Access Compliance Report

Public Rights-of-Way

(Curb Ramps)

Intersection ID: 43503	Main Street: CYPRESS_CT	Cross Street: PRESCOTT_HILL_AV	Location: NW
ADA ID: BC4DA6CA692C	Ramp Type: PerpDiag	Initial Pass/Fail: Fail	Overall Compliance: No
		Severity Score: 22.5

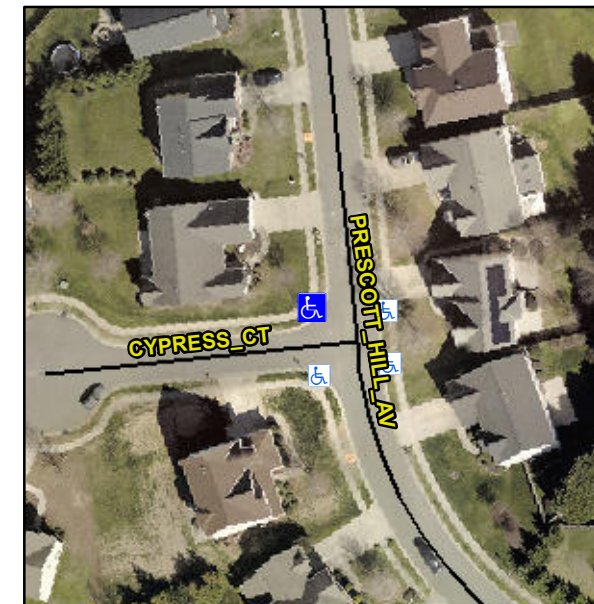
Not Found, R304.5.1, R304.2.2, R304.5.3

Compliance	Description	Data	Compliance	Description	Data
N/A	Ramp Length (in)	46.0	No	Ramp Slope (%)	9.2
No	Ramp Width (in)	44.0	No	Ramp XSlope (%)	2.2
N/A	Flare Type LT	N/A	N/A	Flare Type RT	N/A
N/A	Flare Slope LT (%)	N/A	N/A	Flare Slope RT (%)	N/A
N/A	Flare Traversable LT?	N/A	N/A	Flare Traversable RT?	N/A
N/A	Landing Length (in)	N/A	N/A	DWS Provided?	N/A
N/A	Landing Width (in)	N/A	N/A	DWS Contrast?	N/A
N/A	Landing Slope (%)	N/A	N/A	DWS Length (in)	N/A
N/A	Landing X Slope (%)	N/A	N/A	DWS Full Width?	N/A
N/A	Landing Curb? (Y/N)	N/A	N/A	DWS Offset (in)	N/A
N/A	Shared Landing?	N/A			
N/A	Gutter Ponding?	N/A	N/A	Gutter Slope (%)	N/A
N/A	Gutter Lip Ht (in)	N/A	N/A	Gutter X Slope (%)	N/A
N/A	Painted X Walk1?	No	N/A	Painted X Walk2?	No
	X Walk 1 Direction	To S		X Walk 2 Direction	To E
N/A	X Walk 1 Width (in)	N/A	N/A	X Walk 2 Width (in)	N/A
	X Walk 1 Slope (%)	0.1		X Walk 2 Slope (%)	3.6
	X Walk 1 X Slope (%)	2.6		X Walk 2 X Slope (%)	1.8

Remove & Replace Curb Ramp With Two New Directional Ramps or Equivalent.
